# Work Order ID 97747

Item Name: Replacement Skidtube

DRAWING NO. D2580	TITLE 205 SKIDTUBE ASSEMBLY	REV. E	DART AEROSPACE LTD ENGINEERING ORDER		D.E.O. NO. D2580-E-1	SHEET NO. SHEET 1 OF 1	SCALE NTS
DRAWN <i>UP</i>	CHECKED <i>ASS</i>	MFG. APPR. <i>EC</i>	APPROVED <i>[Signature]</i>	DE APPR. <i>[Signature]</i>	DATE 11.12.13	DATE 11.12.13	DATE 11.12.13

CHANGE ALL C'BORED WELDED CROSSBOLT SPACERS TO SWAGED SPACERS

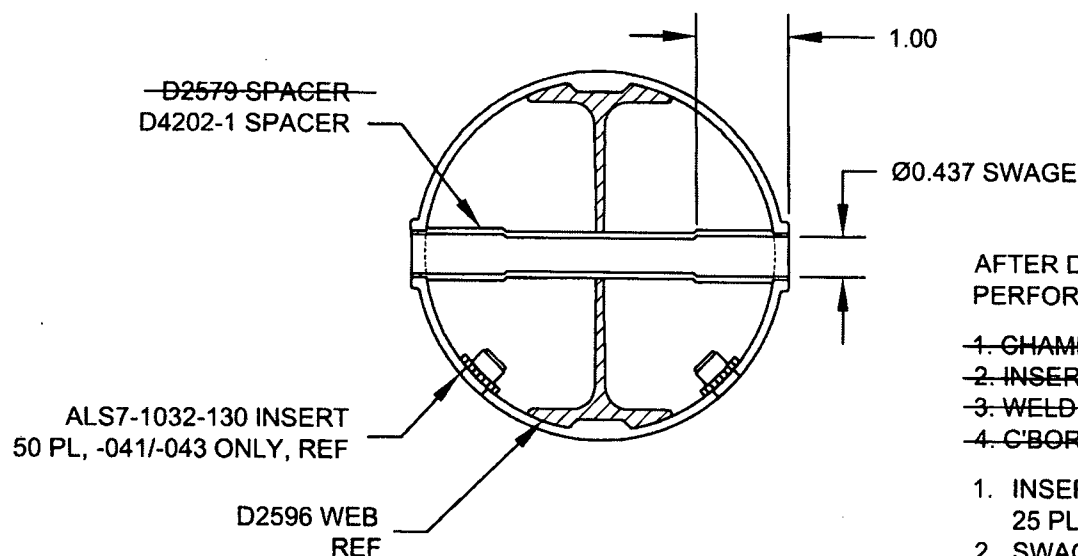
QTY	QTY	QTY	PART NUMBER	DESCRIPTION
-041	-045	-047		
20	24	25	D2579	CROSS BOLT SPACER

IS

4		* D2579	CROSS BOLT SPACER
20	20	25	D4202-1	SPACER

SECTION B-B, SECTION F-F, & SECTION I-I ARE AMENDED AS FOLLOWS  
FOR ALL HOLES THAT WERE ORIGINALLY C'BORED:

WELD 4X D2579 SPACERS PER DWG  
IN LOCATIONS MARKED "NO C'BORE".  
REF SHEET 4 OF DWG.
